WEST LINN PLANNING COMMISSION

FINAL DECISION NOTICE

SUB-12-01

**IN THE MATTER OF A PROPOSED FIVE LOT SUBDIVISION
AT 23112 BLAND CIRCLE**

Figure 10: Fence along West Side of Driveway

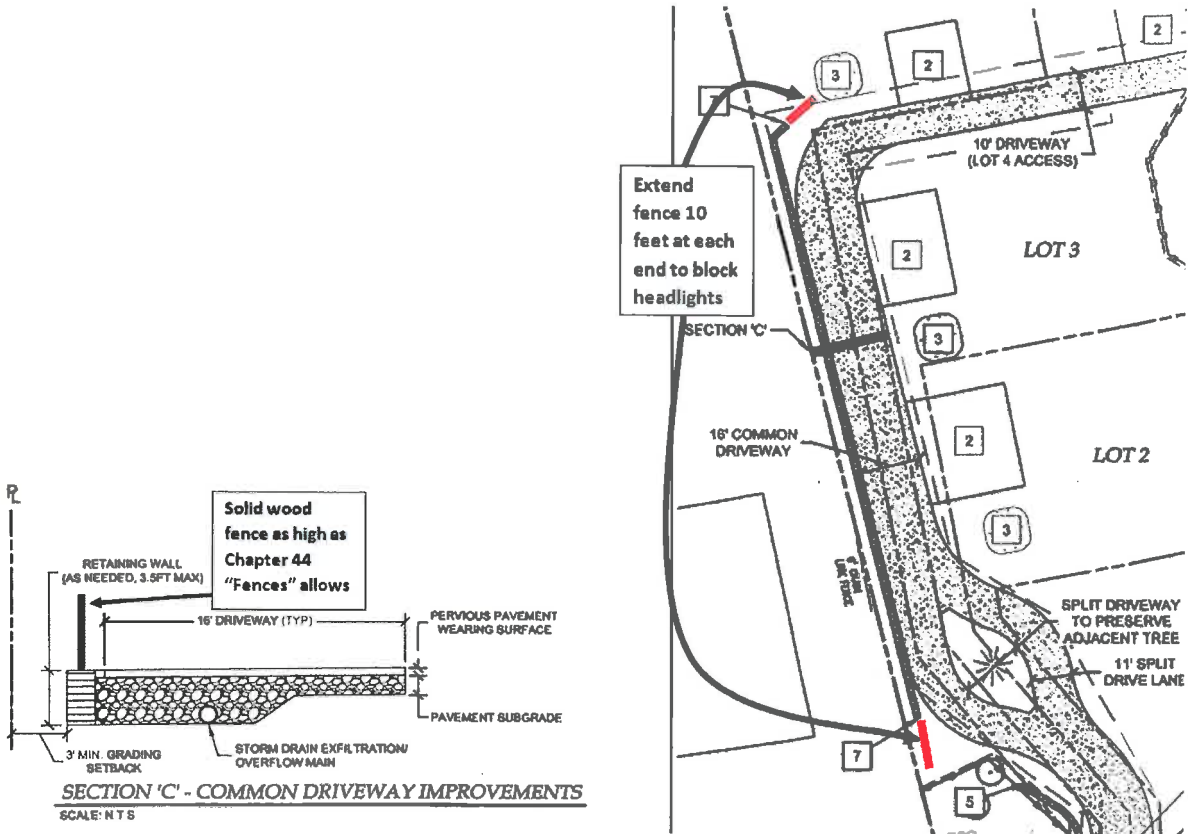
7. Fence. To shield the property to the west (23906 Bland Circle tax lot 501) from the headlights of vehicles using the driveway, the applicant shall install a solid wood fence, as high as Chapter 44 allows, on top of the retaining wall or graded slope along the west edge of the driveway (see illustration below). The fence shall either have the "good side" facing west with the construction side facing east or be identical on both sides. The fence shall extend ten feet beyond each end of the retaining wall shown on sheet C 2.1 (see Figure 10 below).
